RE: LU 32024-0715 Hersog Meier VW Volvo Service Bldg (FDG # E20-030)

This letter is submitted to summarize the responses to the Completeness and Site Development Comments noted in the incomplete letter dated 9-4-24. Our responses list the item of reference per the letter and provide the action taken to address the review comment.

**HERZOG MEIER
VOLKSWAGEN-VOLVO
NEW SERVICE BUILDING**
4275 SW 139TH WAY
BEAVERTON, OR 97005

SHEET TITLE
SITE PLAN
SHEET NO.

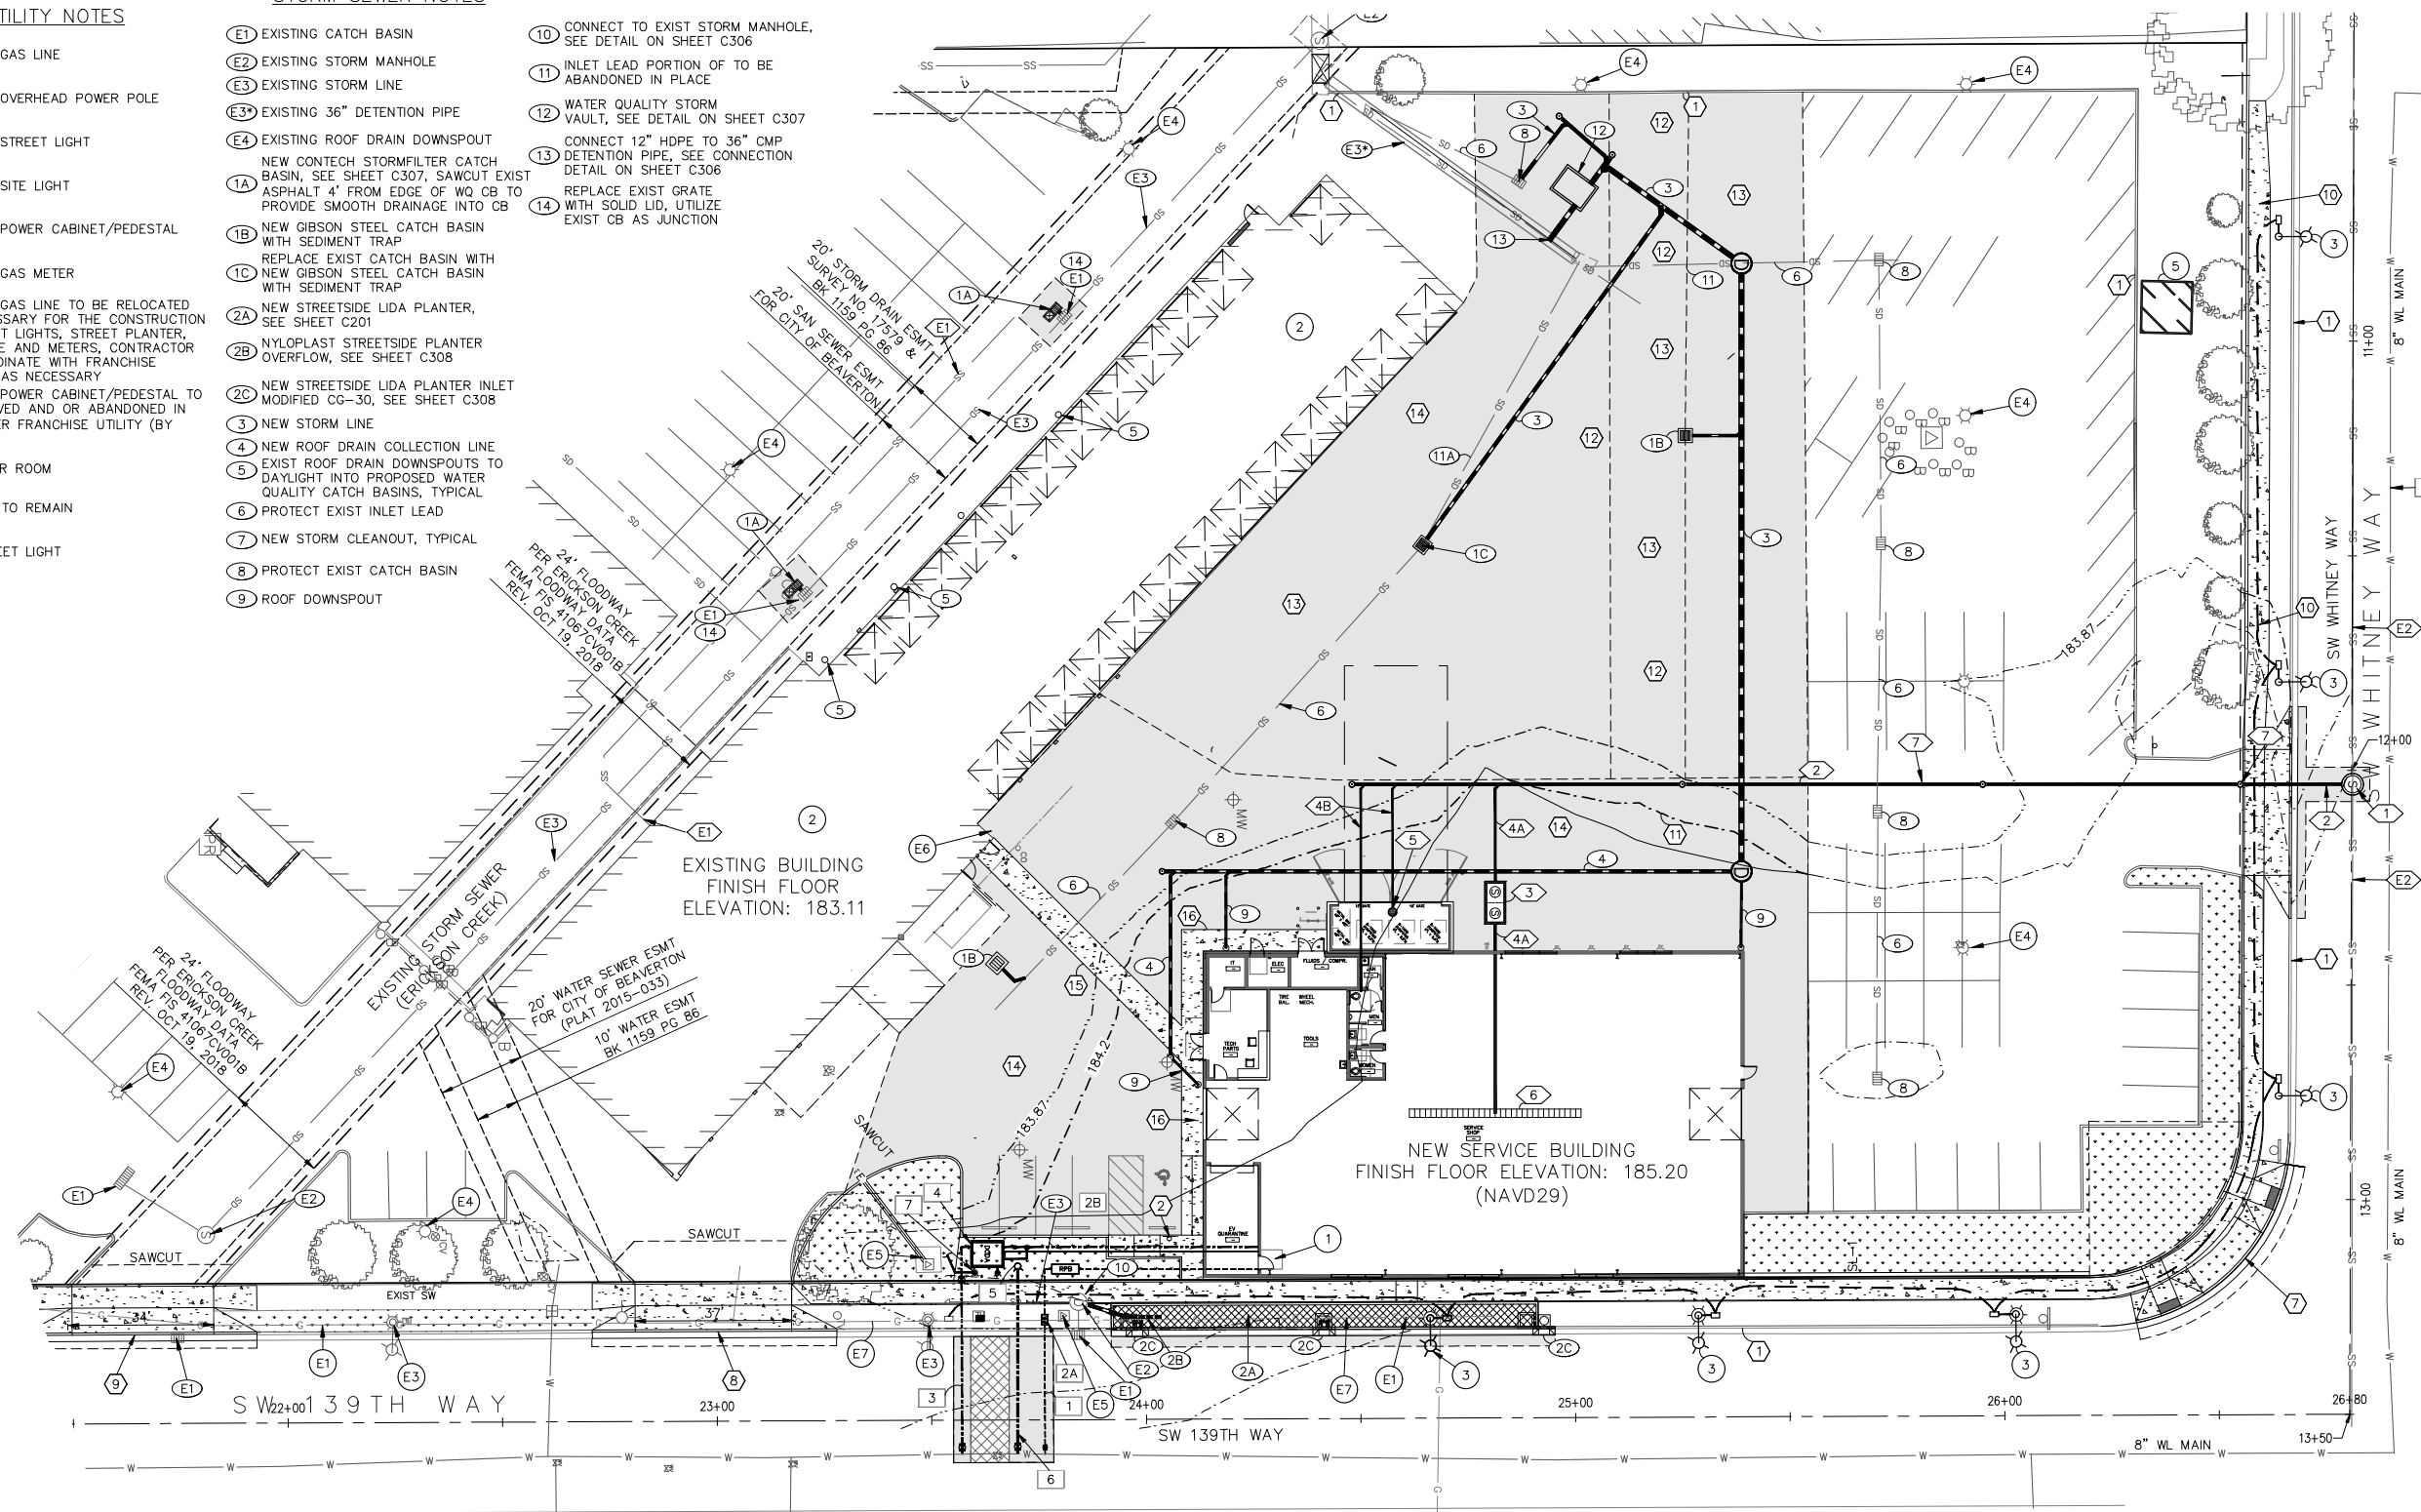
Please ensure that CWS reviews and signs off on a current version of the site plan. The one that was provided to CWS appears to be the site plan associated with the 2022 modification.

RESPONSE: A new Pre-Screen application was submitted to CWS with the current site plan and CWS provided the same determination of no significant impact. See enclosed documentation from CWS.
